A G E N D A

Architectural Review Board

September 25, 2018

728 Felder Avenue

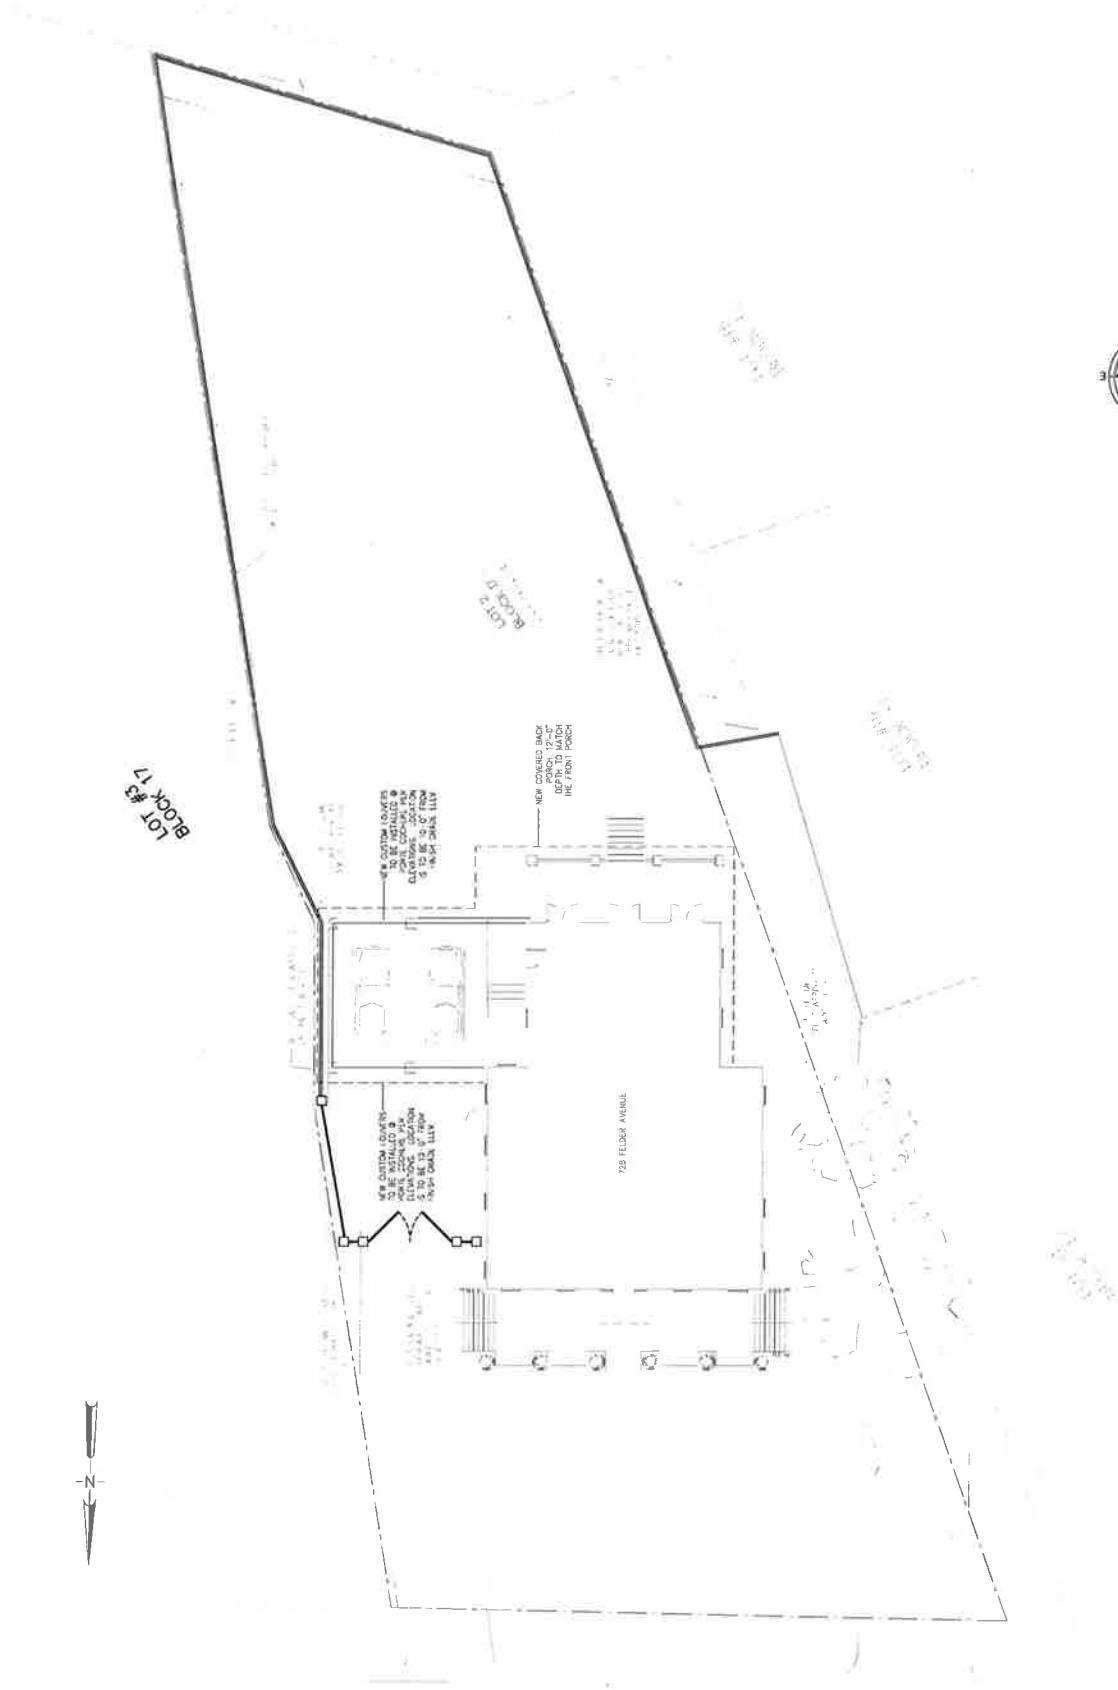
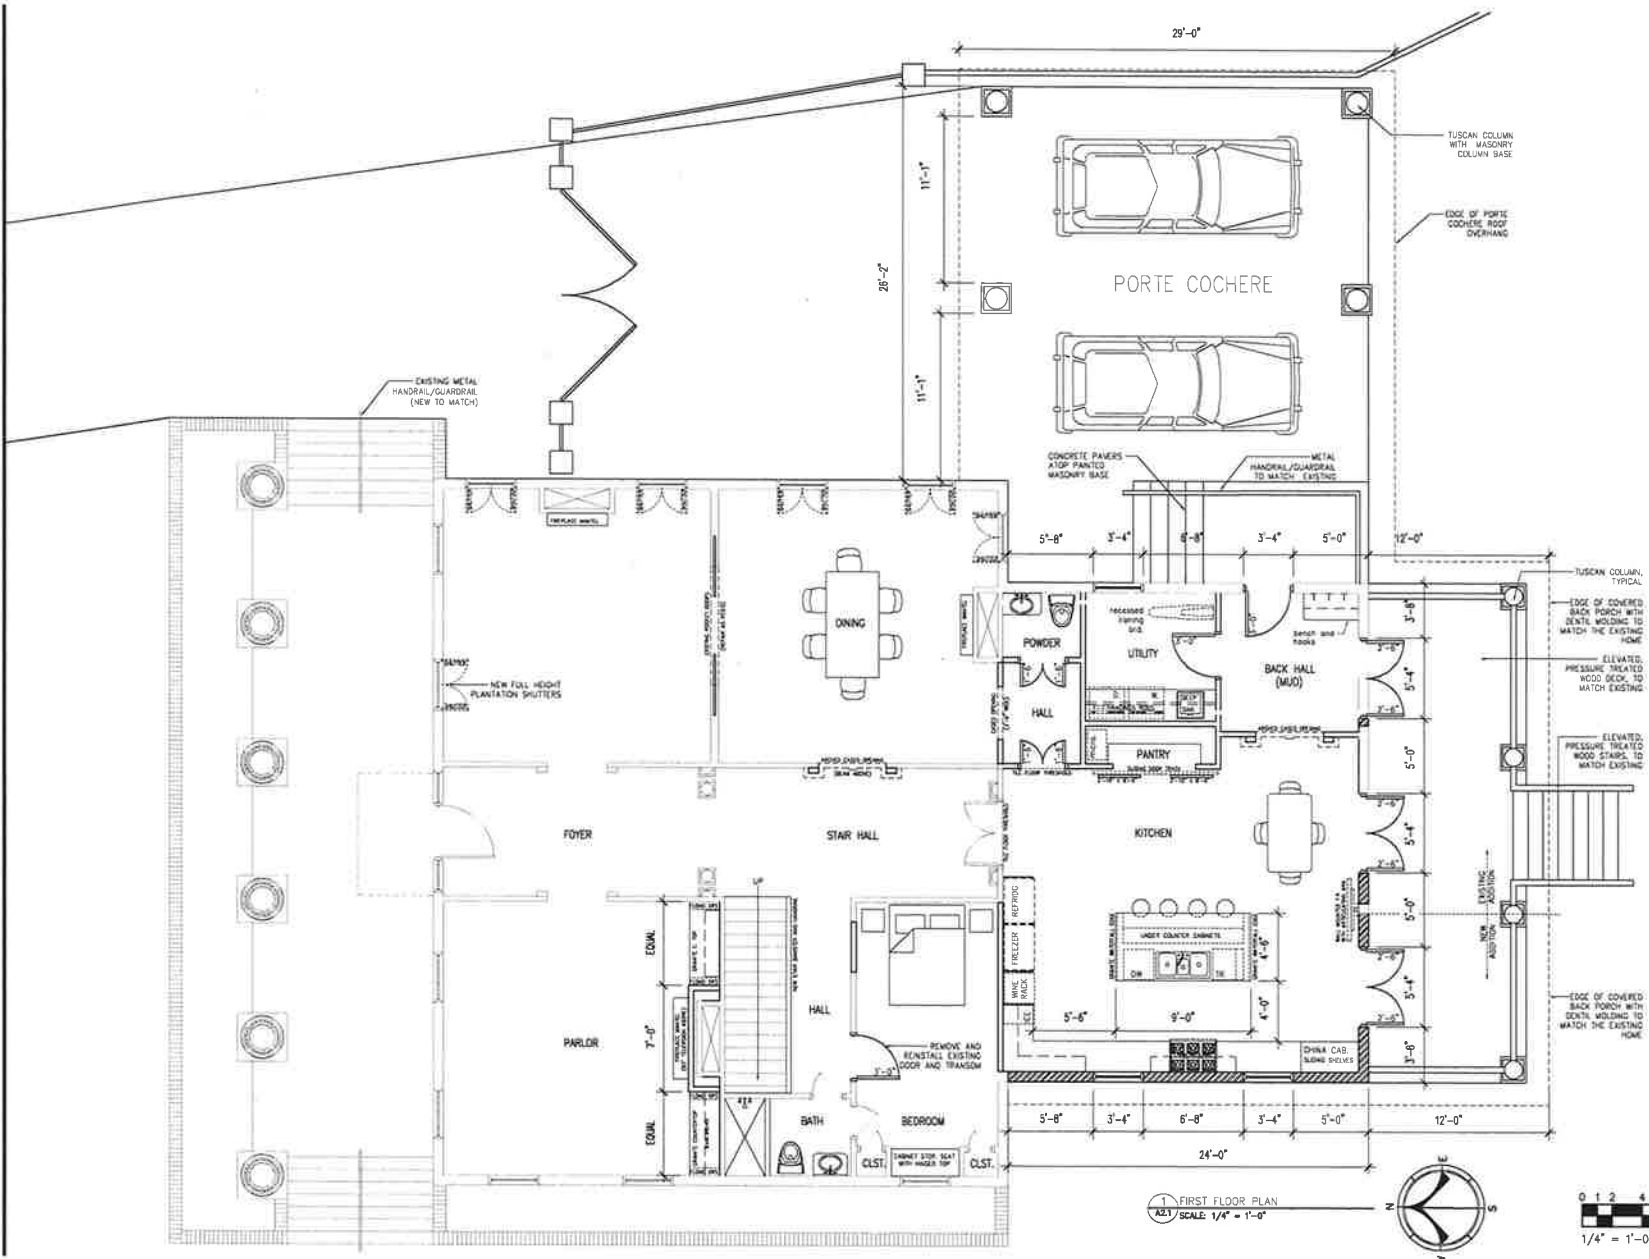
- The property previously had an open deck, so this proposal does not materially expand the overall footprint, only extends the roofline.
